The Sandstone Precinct: MOD 7 Design Report

Document Number
SP-RPT-E-MAKE-0005

MOD 7 Design Report

Loftus Street

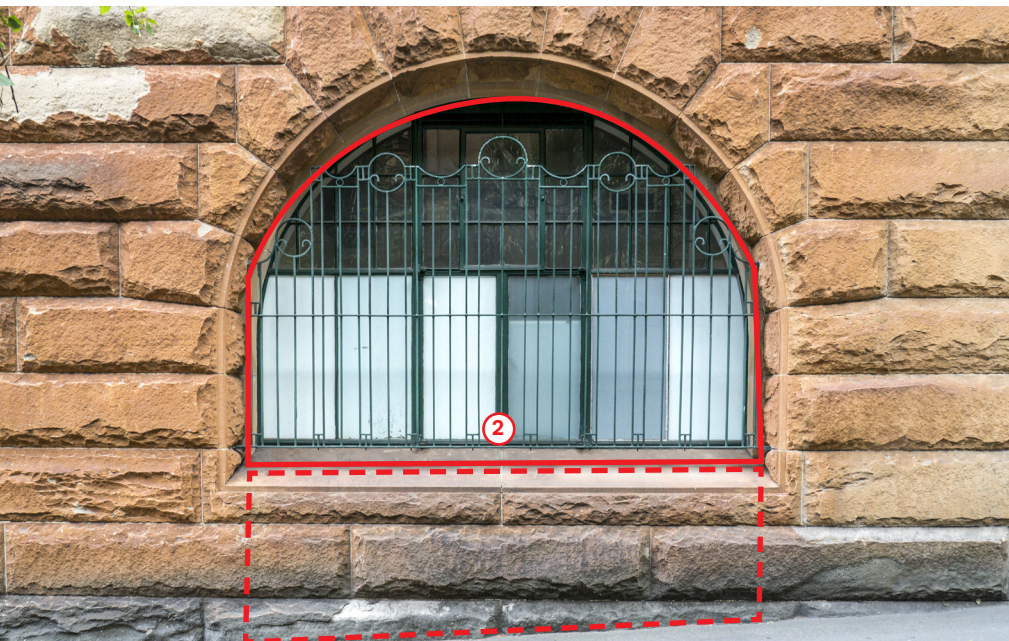
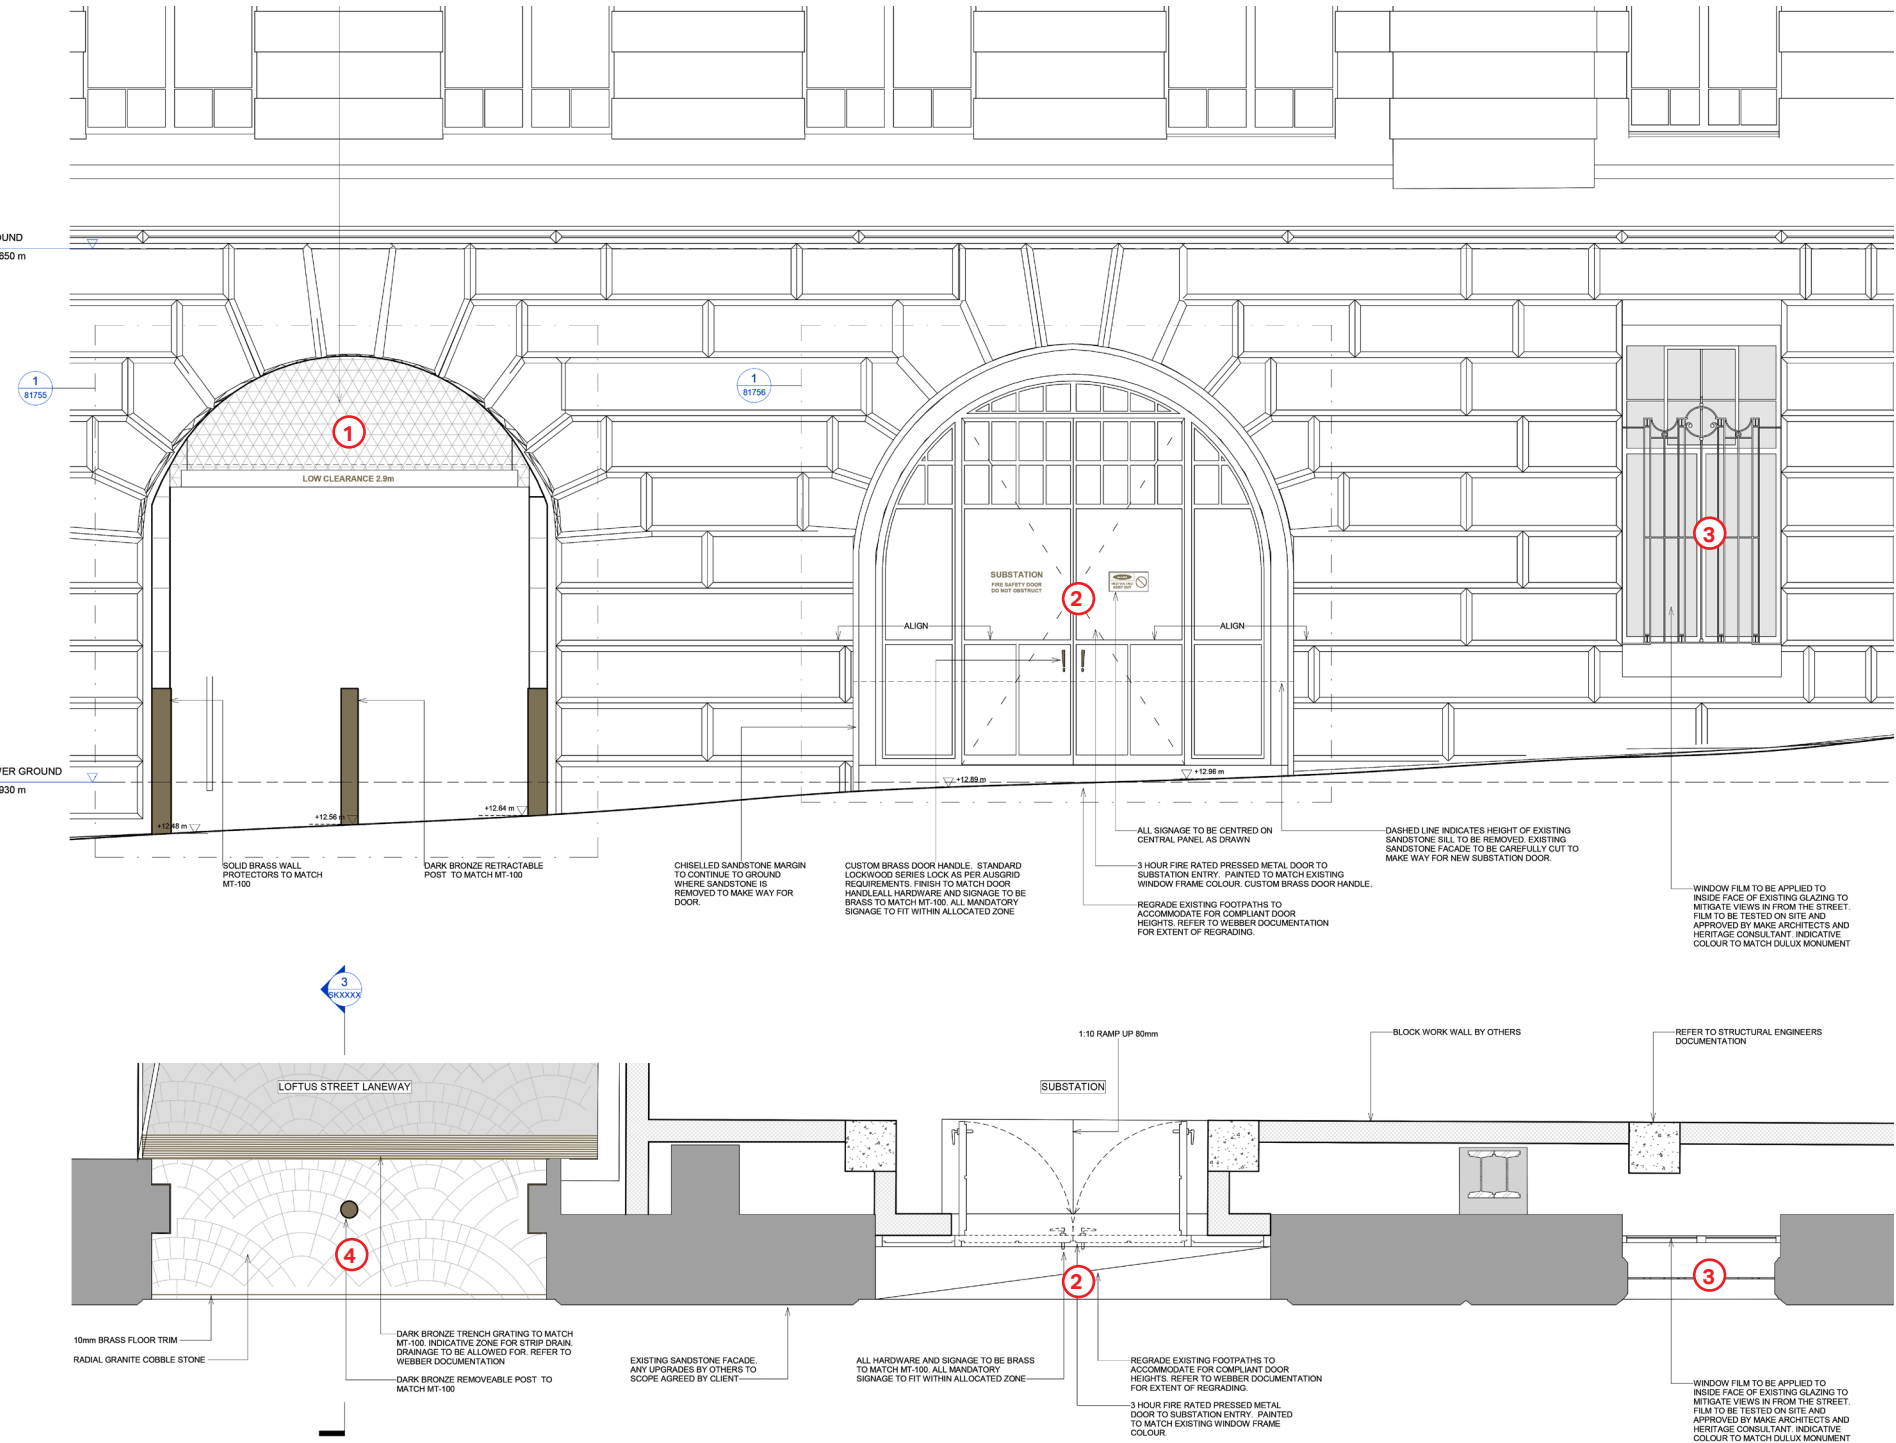
- 1. New custom perforated screen to sit in front of air intake louvre. Anodised finish to match secondary glazing framing colour (subject to Ausgrid approval).
- 2. Remove existing sandstone facade and existing heritage window. Install Ausgrid compliant equipment doors. Fire rated pressed metal door, painted to match existing heritage windows and doors. Custom brass door handle and signage (subject to Ausgrid approval).
- 3. Film applied to inside face of existing glazing to mitigate views in from the street (reversible). Dark charcoal colour to match new perforated screen and secondary glazing frame. Existing decorative window grilles to be repainted and retained in place.
- 4. Removable dark bronze bollard to be installed to create a pedestrian safe zone for guests and prevent vehicles from driving into the Loftus Street laneway

Substation equipment door

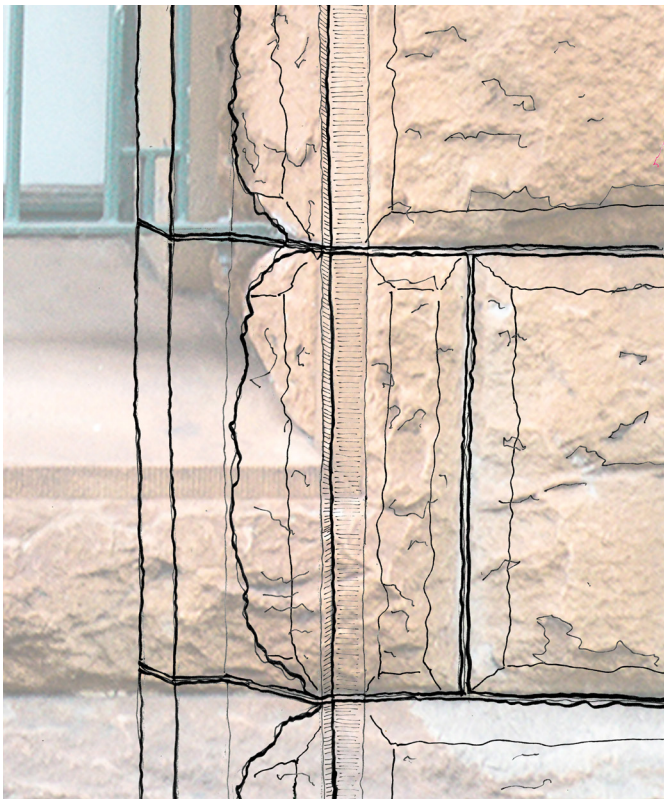
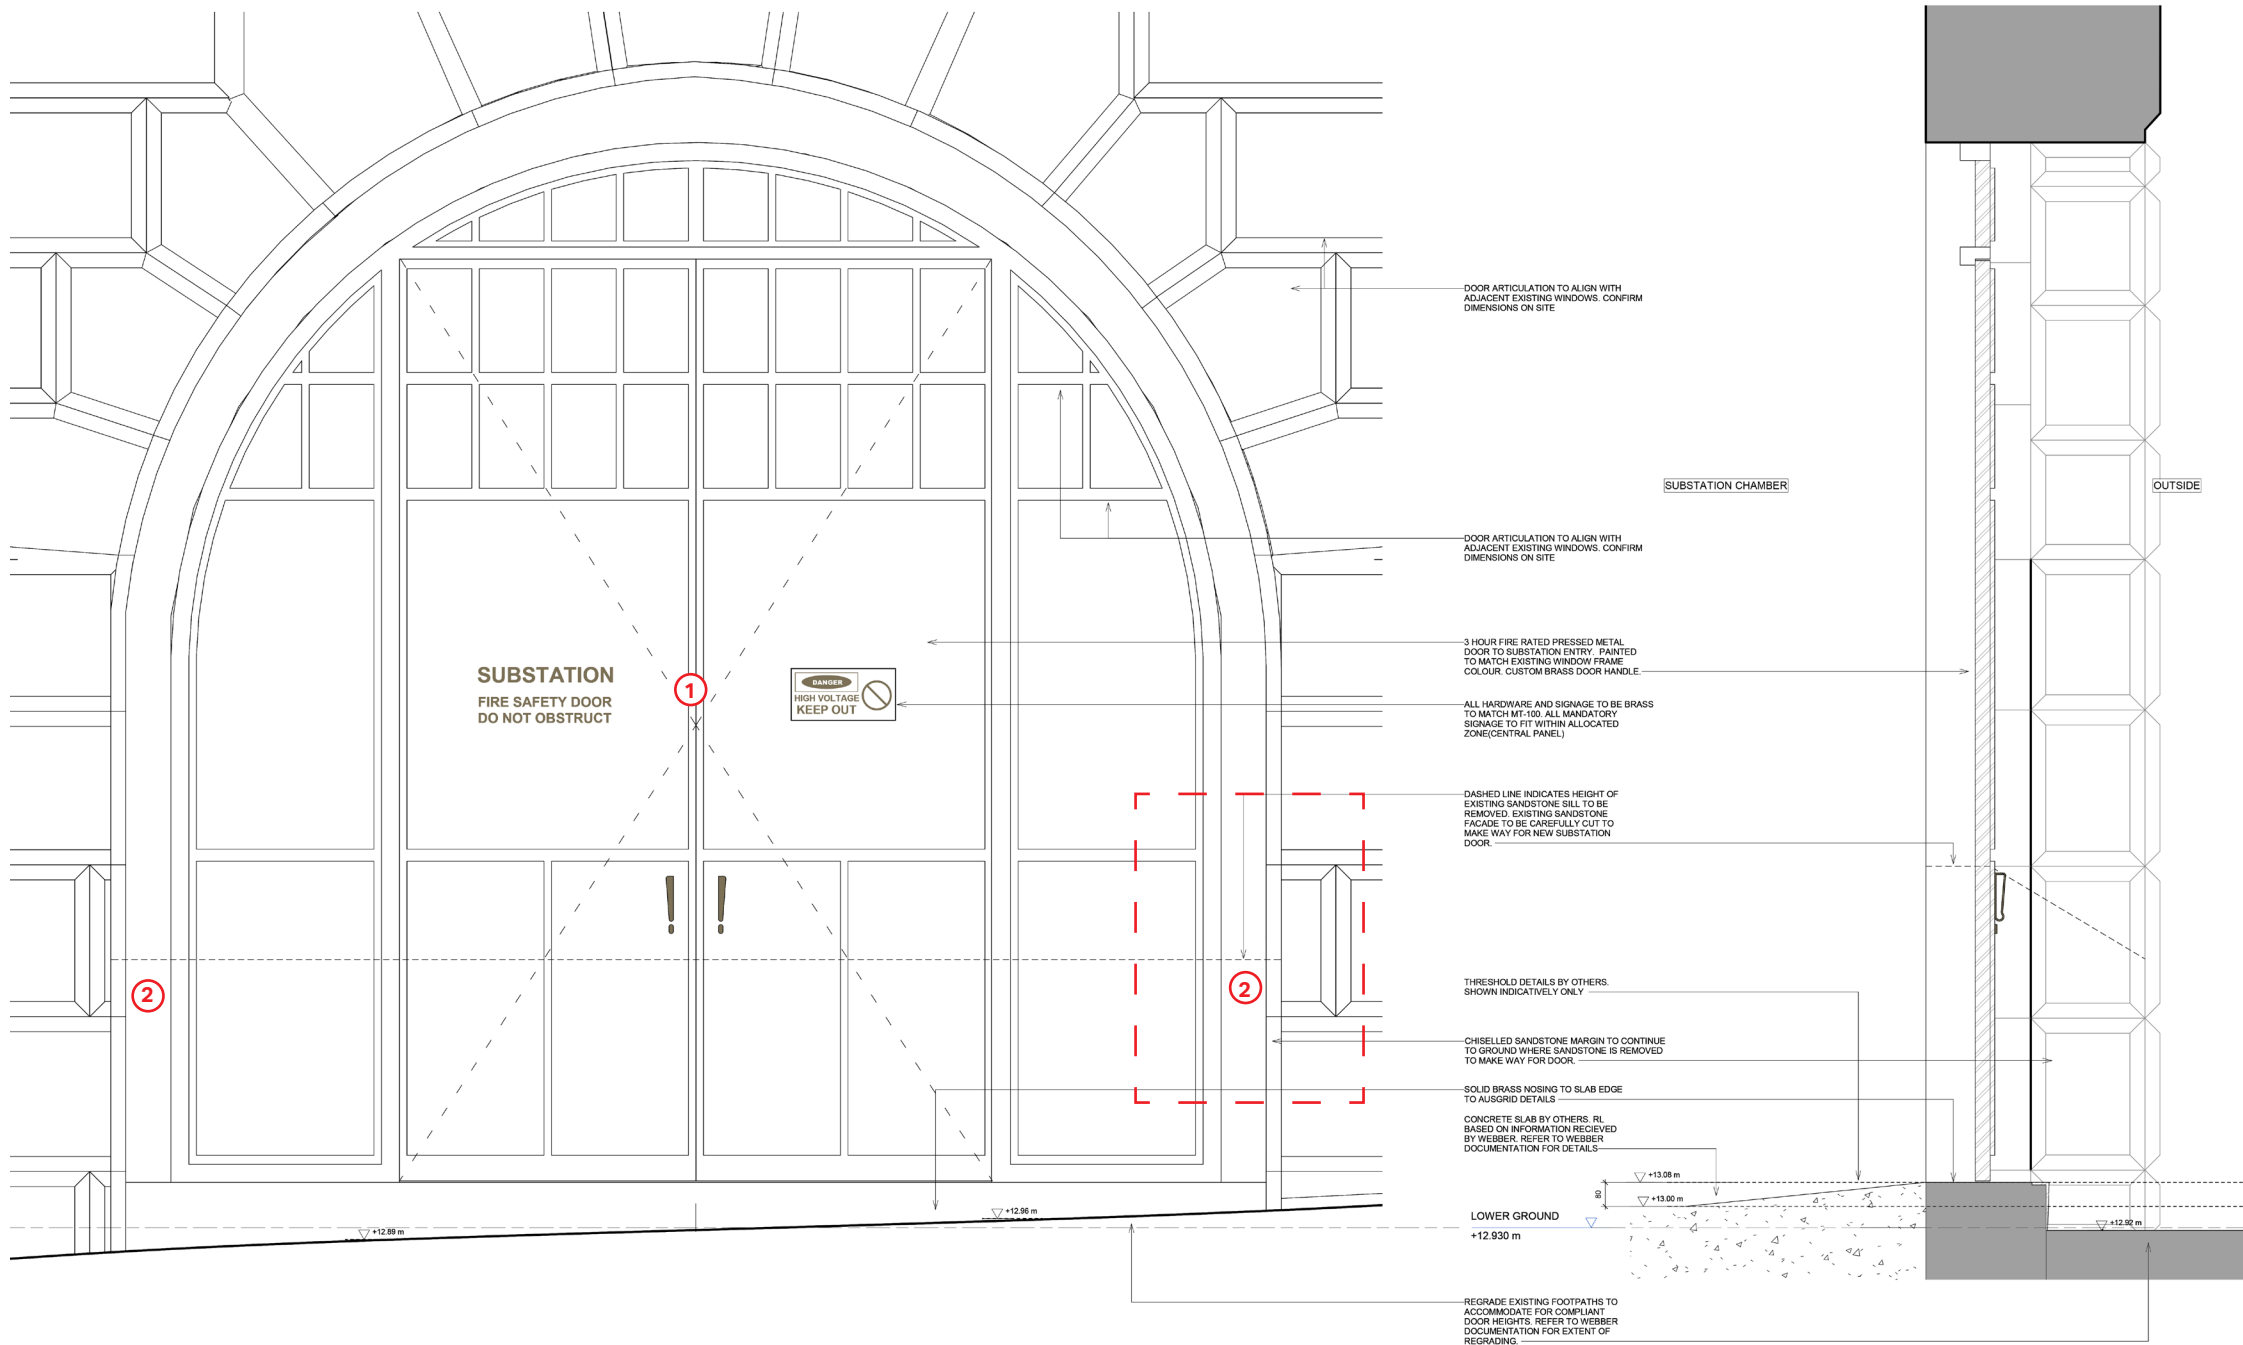
1. Remove existing sandstone facade and existing heritage window. Install Ausgrid compliant equipment doors. Fire rated pressed metal doors. Fire rated pressed metal doors. Painted to match existing heritage windows and doors. Custom brass door handles and signage (subject to Ausgrid approval).
2. Chiselled margin detail and recessed sandstone reveal to be continued to ground to match the existing detail above.

Chiselled margin detail in sandstone facade to be continued to ground (top).
Substation door to be painted dark bronze green to match new paint colour on existing frames (bottom).

Ground floor air intake

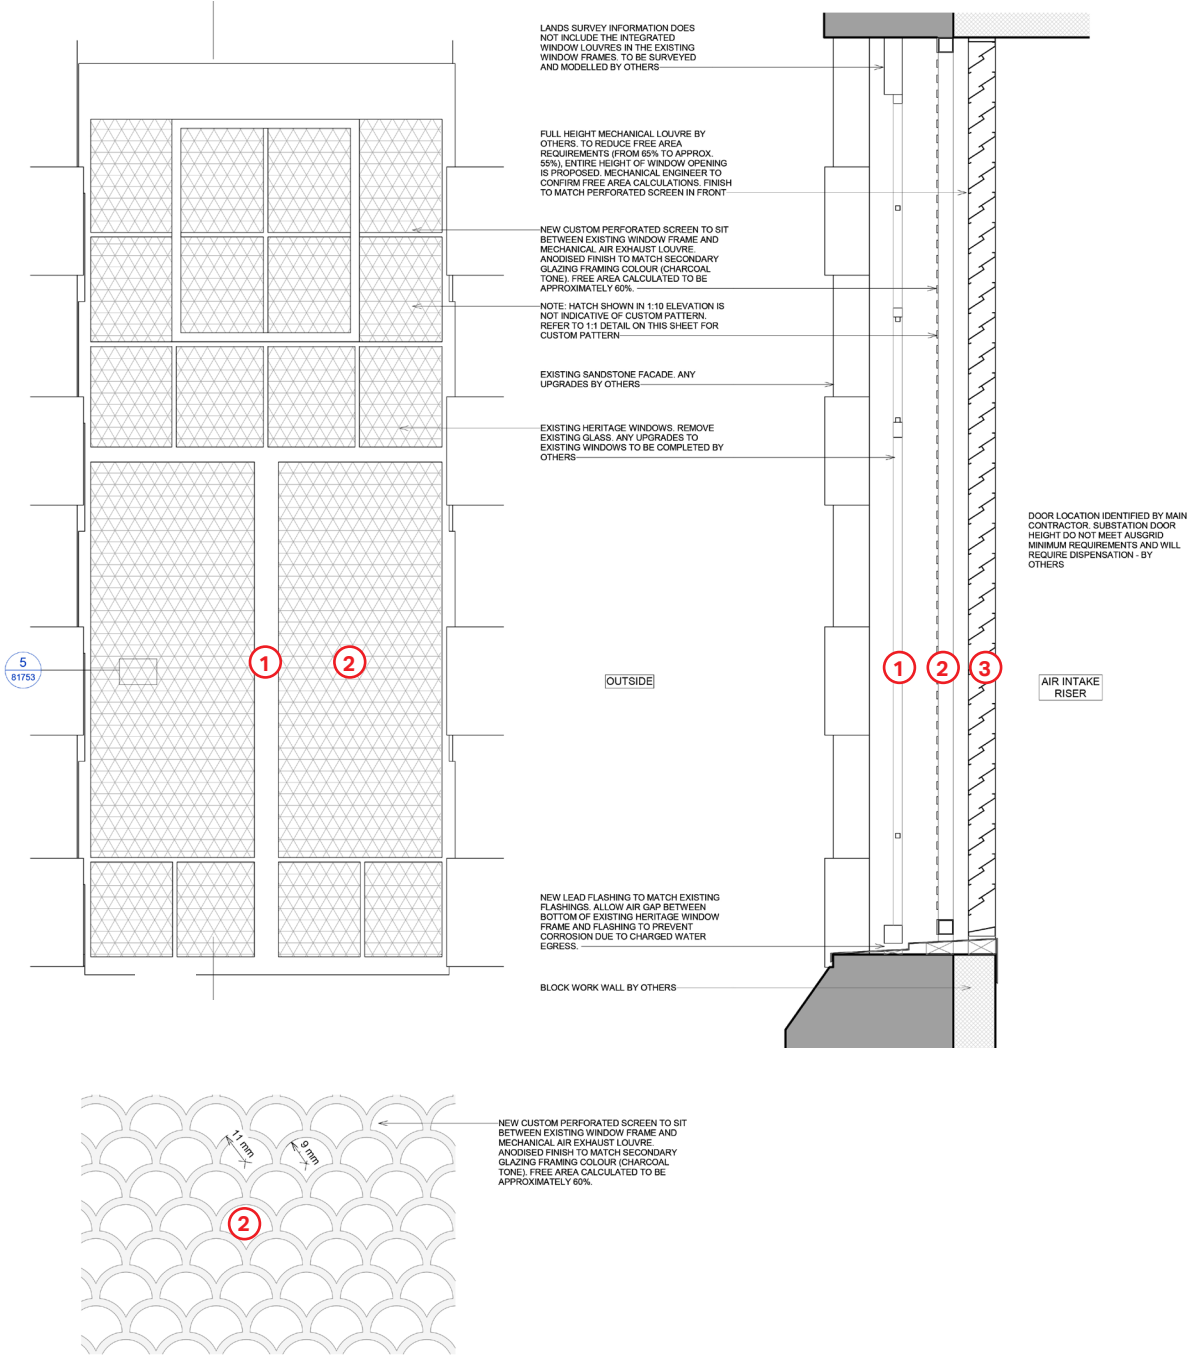
- 1. Existing heritage window. Glazing to be removed and window frame to be made good and repainted.
- 2. New custom perforated screen to sit in front of air intake louvre. Anodised finish to match secondary glazing framing colour (subject to Ausgrid approval). The decorative metal screen above the Farrer Place entrance provides inspiration for the proposed screen pattern (image opposite, top right).
- 3. Ausgrid air intake weatherproof louvre to be anodised to match architectural screen

Lower ground substation door

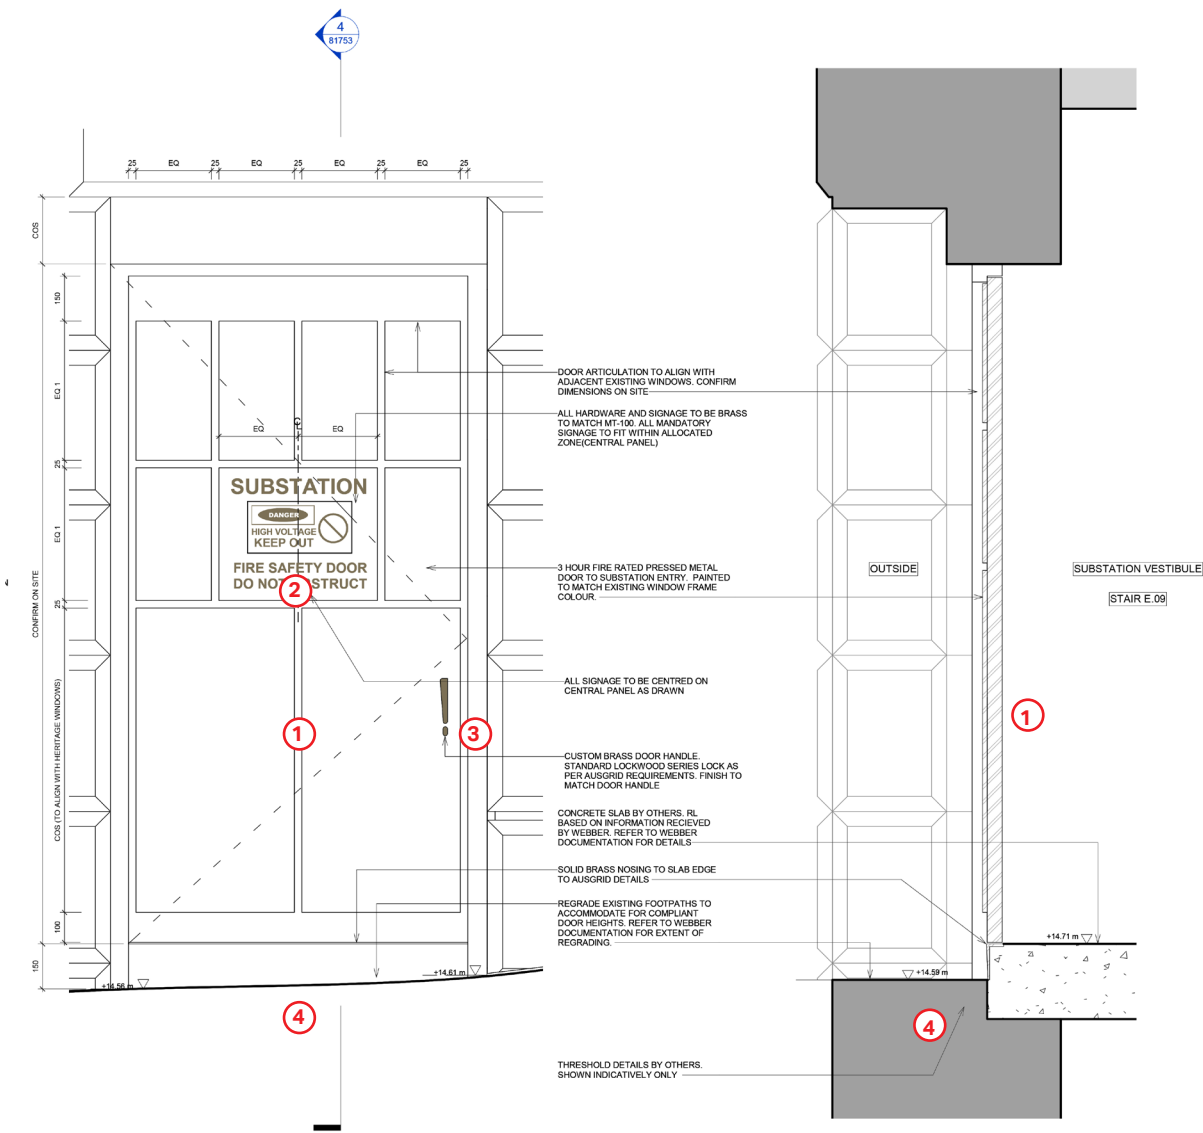
- 1. Existing heritage window to be removed, and replaced with fire rated pressed metal door. Painted to match existing window frame colour (subject to Ausgrid approval).
- 2. Brass signage to Ausgrid requirements
- 3. Custom brass hardware and door handle
- 4. Footpath to be regraded to accommodate for compliant door heights and access
